Urbantech File No. 06-233ph2

**Re: Response to 3rd Engineering Submission Comments
(in support of Draft Plan approval)
Orangeville Highlands Phase 2
Town File No.: 51/10 & OPZ 5/10**

RE: ORANGEVILLE HIGHLANDS – TOWN COMMENT RESPONSE LETTER

**DRAFT PLAN OF SUBDIVISION
ORANGEVILLE HIGHLANDS LIMITED &
BRUCEDALE INVESTMENTS INC.**

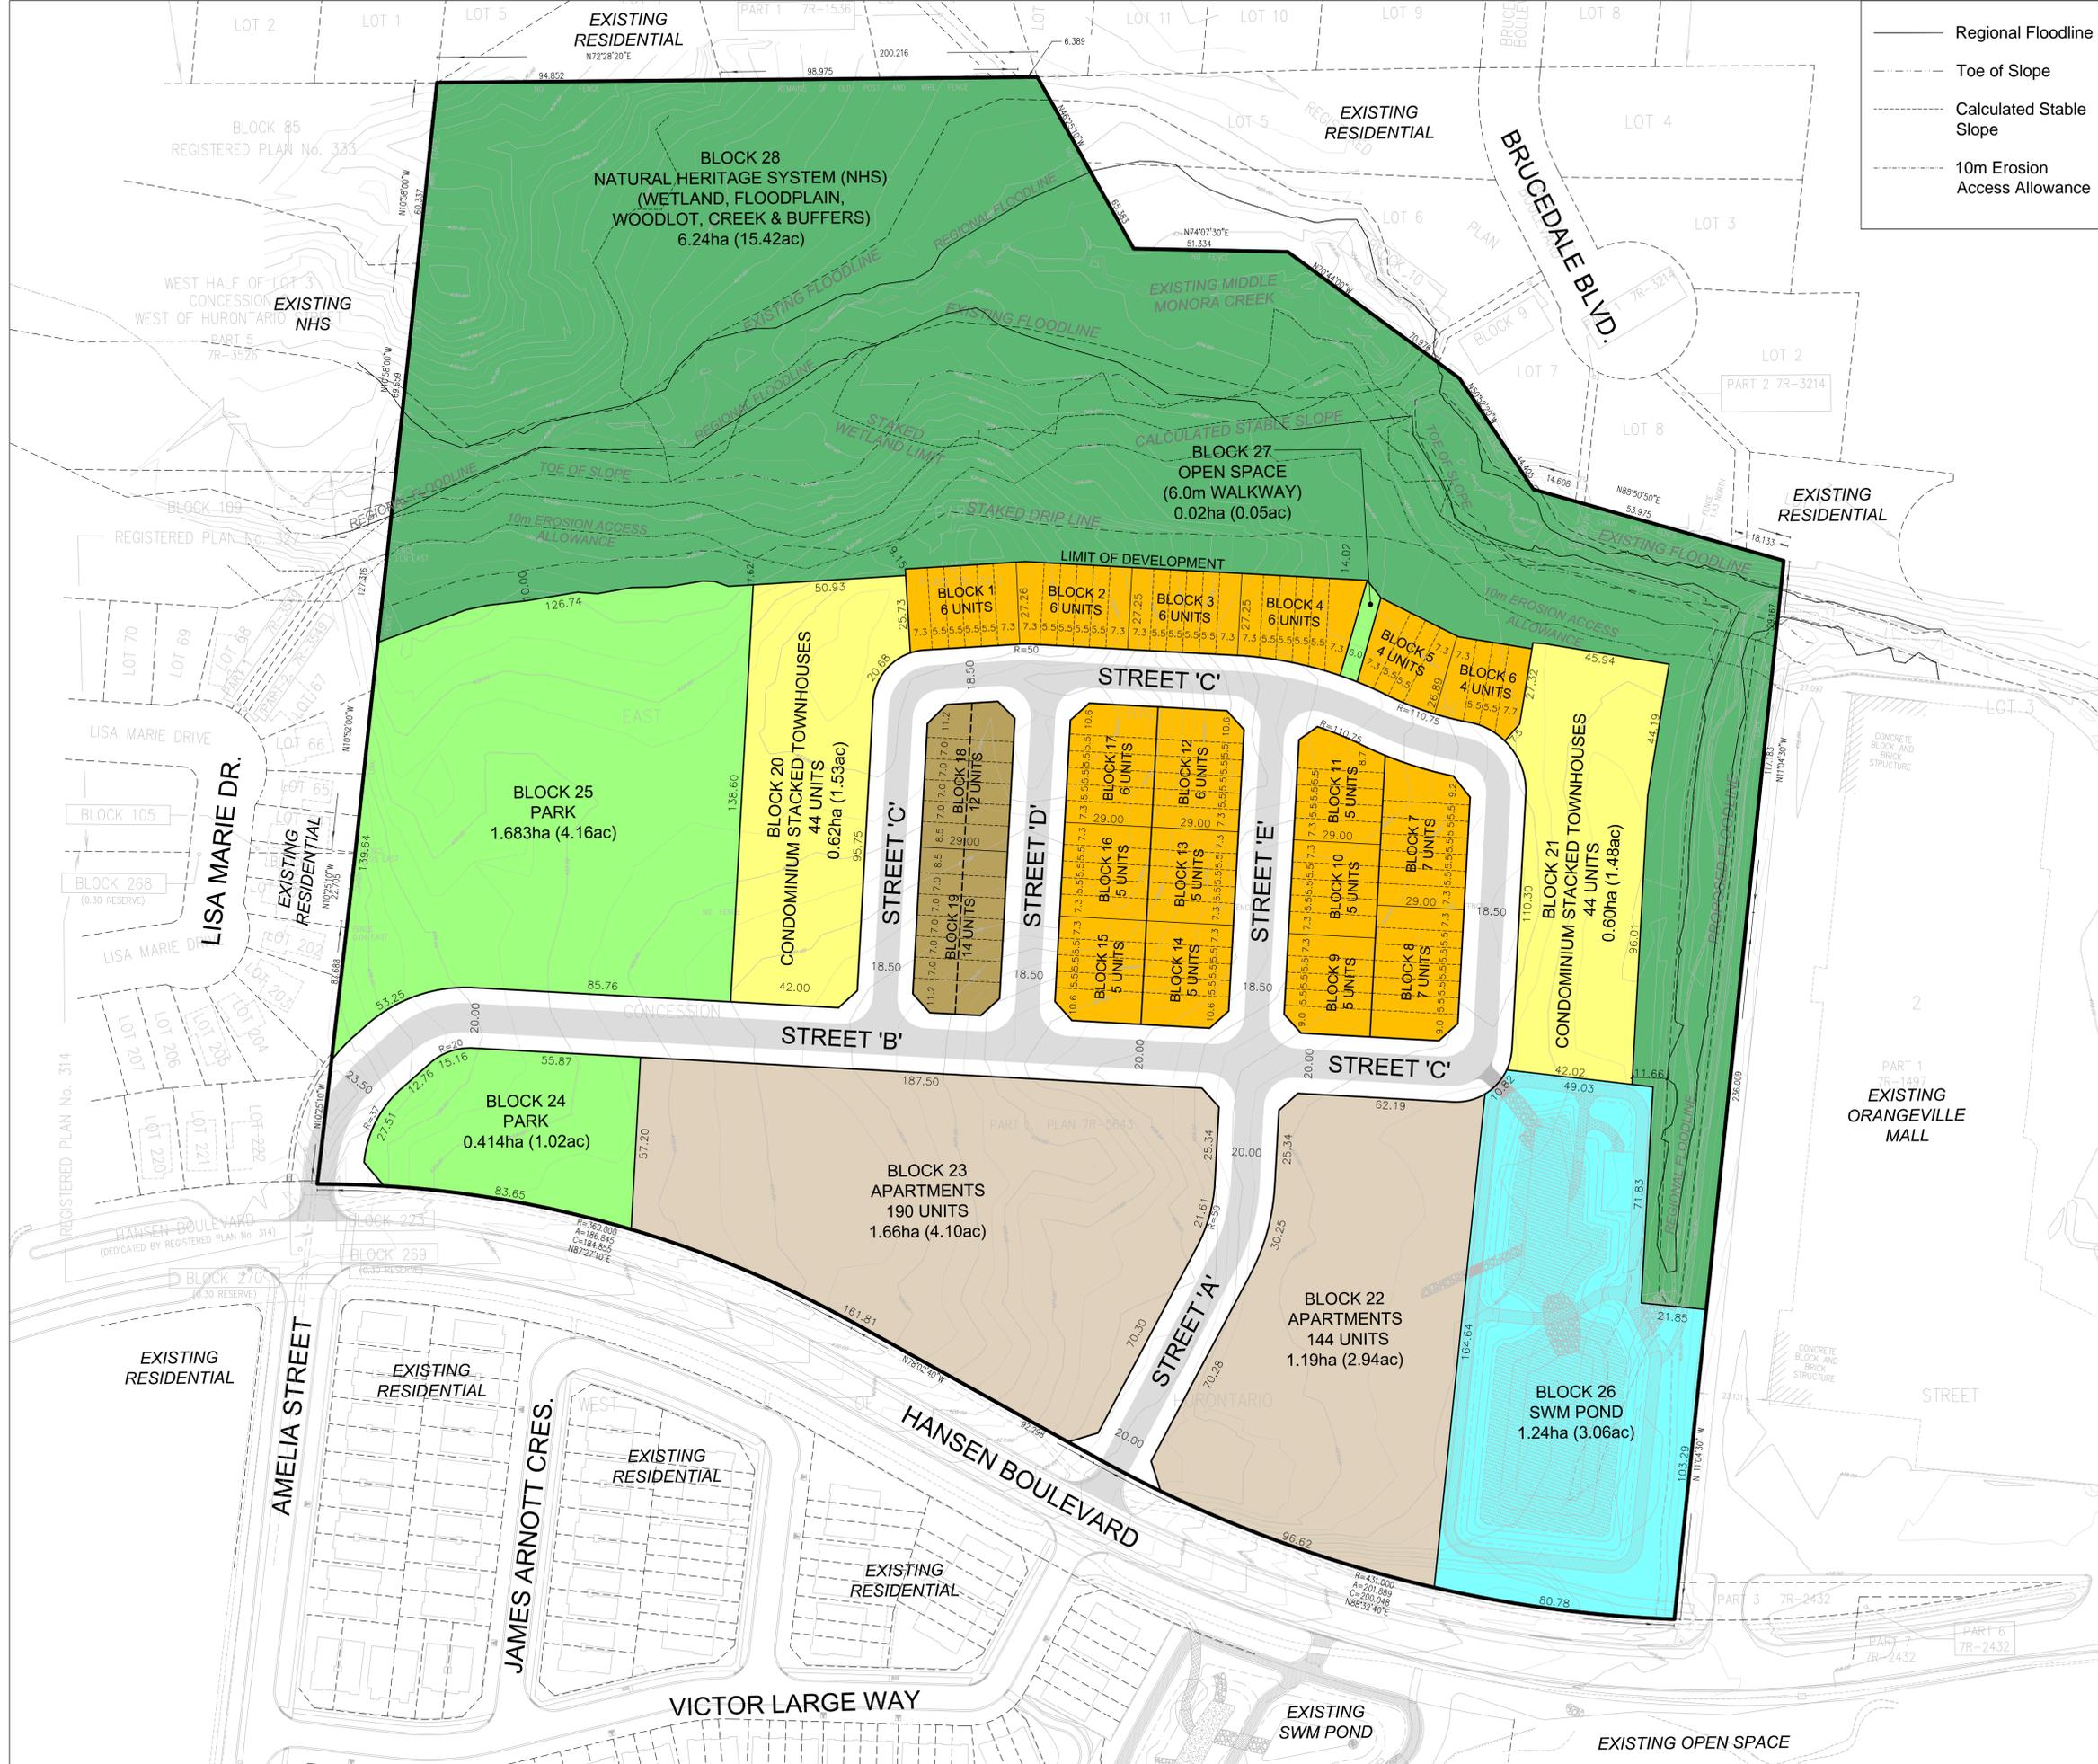
- When Urbantech prepared the FSR and GSAI prepared the Draft Plan of Subdivision, there were some notable issues with the road alignment. Specifically, the “kink” in the road on the northern leg of Street C. We asked that the applicant revisit the configuration to remove the horizontal sag. In our opinion removing the horizontal sag improves driver safety. The next submission should address the issue and the plan(s) revised accordingly;

Please refer to the revised Draft Plan (**Attachment 1**) illustrating a revised alignment for the “kink” in Street C. The revised alignment can be achieved without impacting the number of lots and is in conformance with the engineering design criteria provided by T&D following their 1st submission review (minimum centerline radius = 120m). We request that T&D defer further review to the detailed design stage when more detail can be provided.

TYPICAL CRESCENT CORNER

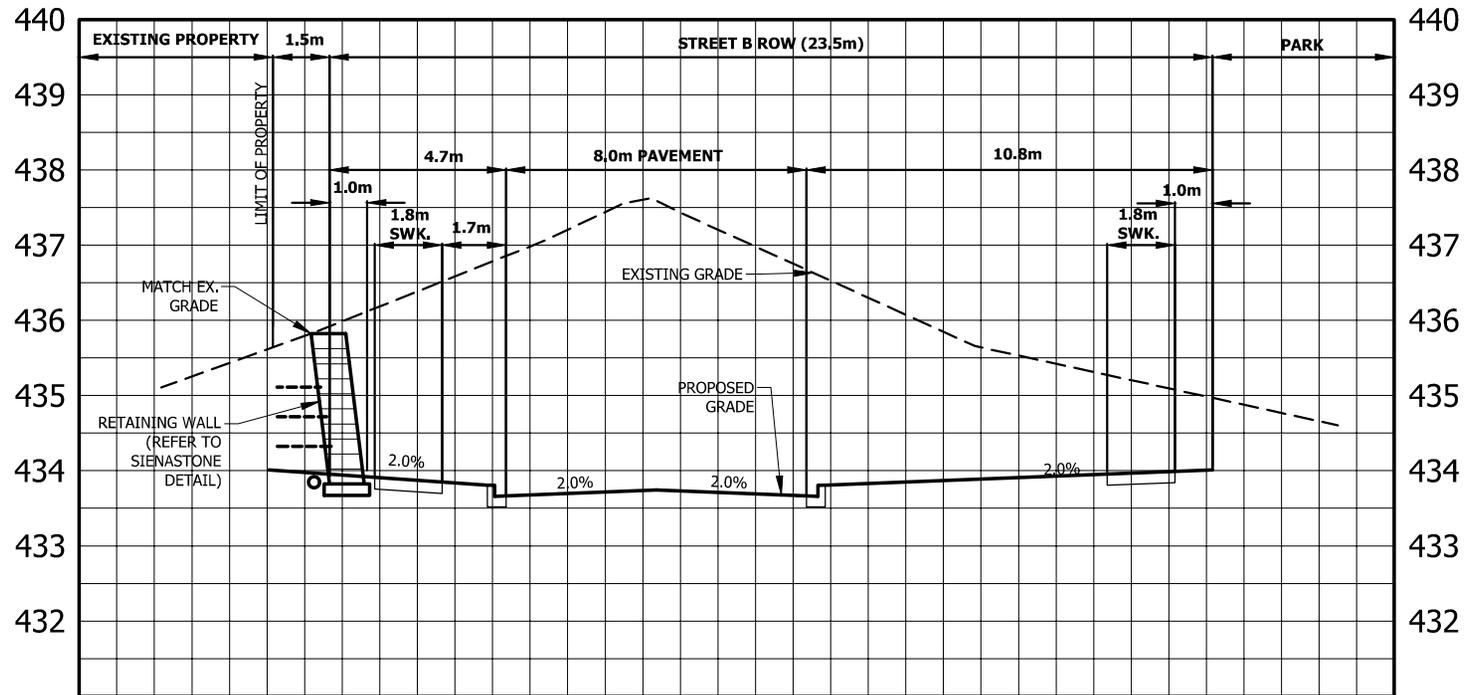
- Crescent corners were requested on 3 corners of Street C. The applicant has not provided the required crescent corners. Revise the plan to reflect that requirement. The radii on the corners can be the same as those used in the first phase of this development and the subdivision to the south.

Please refer to **Attachment 2** for a sample from Phase 1. In this case, the crescent corner was achieved within a 15m wide right-of-way without impacting the draft plan. Accordingly, the requested crescent corners will also be able to be achieved on Street ‘C’ which is an 18.5m wide right-of-way. As this does not impact the draft plan, we request that T&D defer further review to the detailed design stage when more detail can be provided for context, including detailed grading plans.
